UNITED STATES
NUCLEAR REGULATORY COMMISSION
WASHINGTON, D. C. 20555

AUG 11 1980

We have reviewed the revised Draft Environmental Statement concerning the Russellville Municipal Airport relocation. Our review indicates that the selected site for airport relocation (Site 7 in the environmental statement) has the proposed 6000 ft runway aligned with the Arkansas Nuclear One nuclear power station. We estimate that the projected general aviation traffic (24500 annual operations by 1996) will increase the probability of an aircraft crash on the nuclear power station structures to a level considered to be marginally acceptable by the NRC staff in the normal safety review of nuclear power plant license applications. Previous staff analyses of aircraft impacts on plant structures indicate that crashes involving light aircraft are not expected to produce significant damage to typical nuclear plant structures. Our concern, however, is that the presence of a 6000 ft runway, coupled with the commercial growth potential of the area, could lead to future airport expansion and the possible introduction of commercial aircraft using the airport. Impacts from larger jet aircraft, and commercial typ

Site 7
 Plan B Profile
 Russellville Airport Master Plan
 Figure 6-8

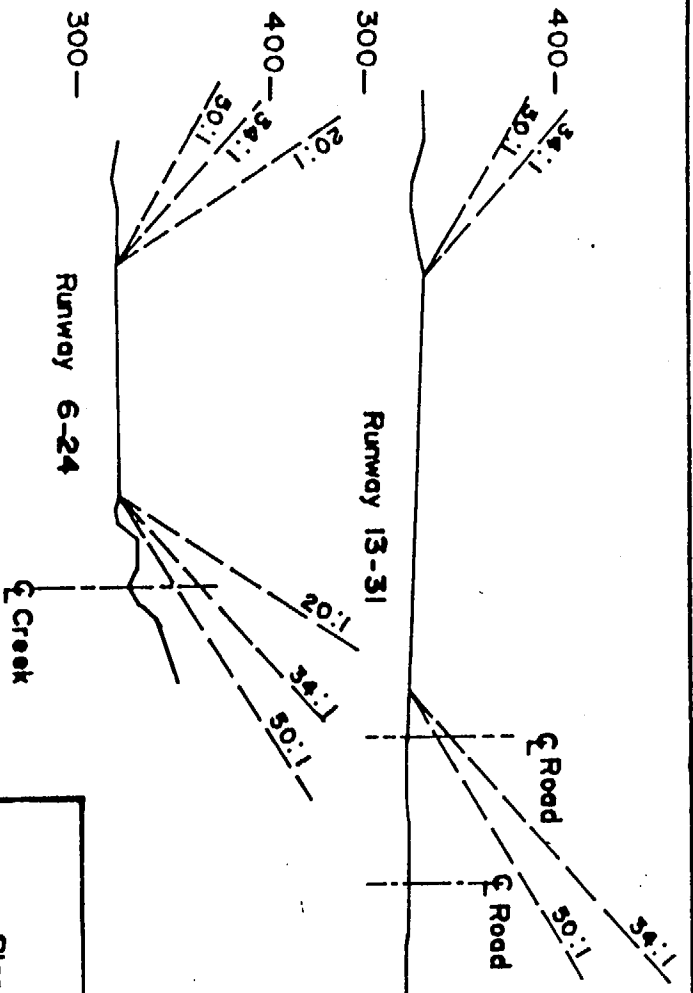
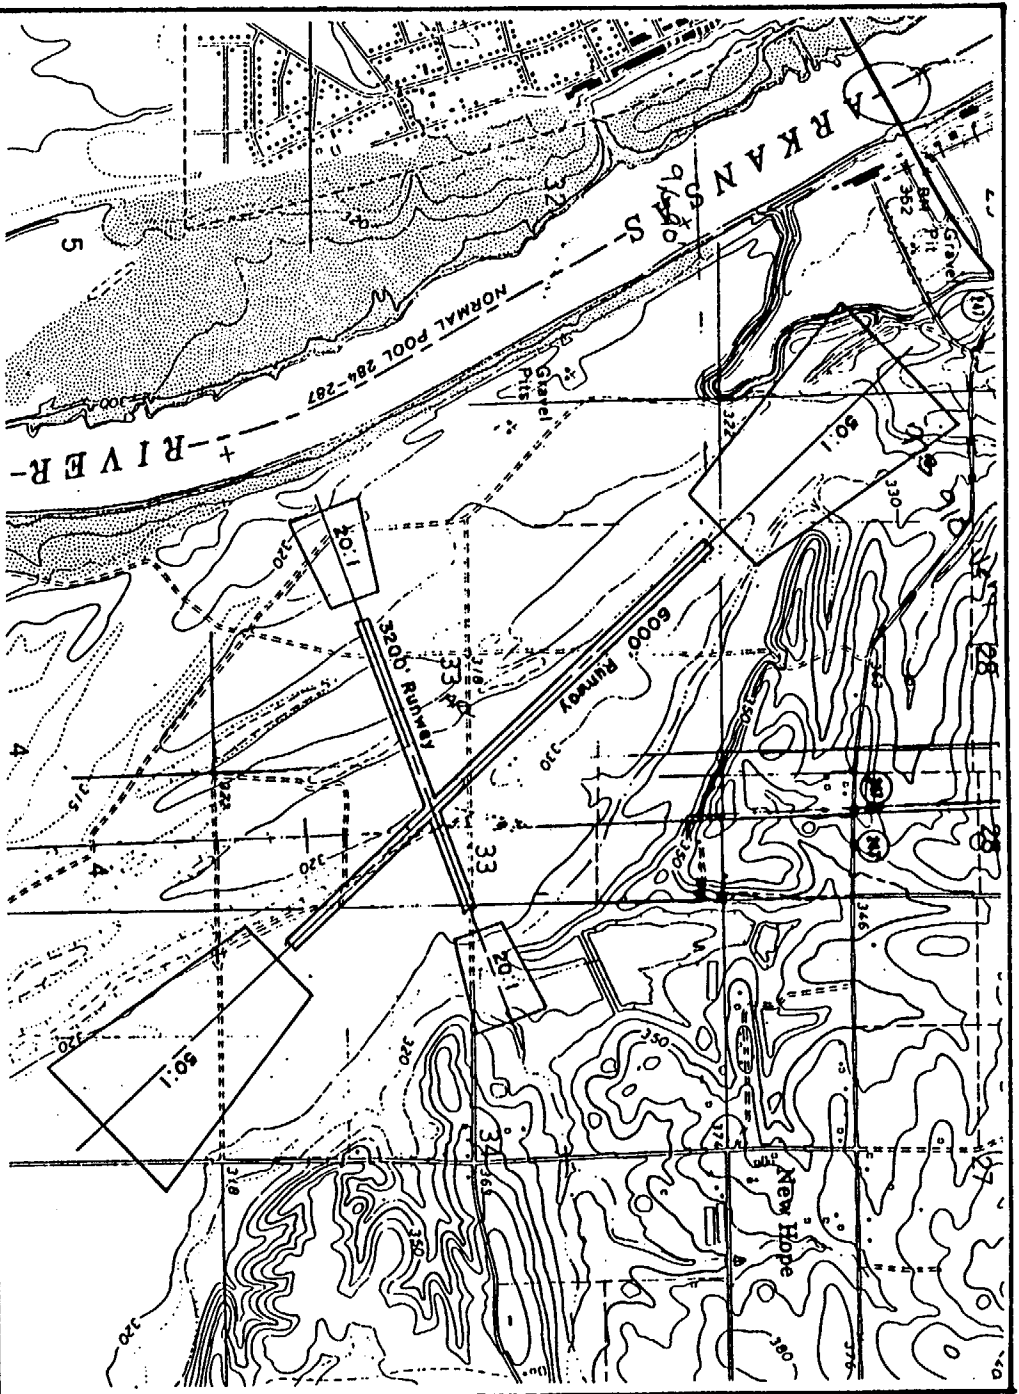
The above considerations indicate that the proposed airport relocation has the potential for becoming a hazard to the operation of the nearby nuclear power station and, hence, can pose an undue risk to the health and safety of the public in the area. We request that the proposed 6000 ft runway be realigned, so that its extension is well away from the nuclear power station. As a minimum, a revised runway orientation should be no less than 30 degrees from the direction of the nuclear power station. Alternatively, the airport should be relocated well beyond 5 miles from the station.
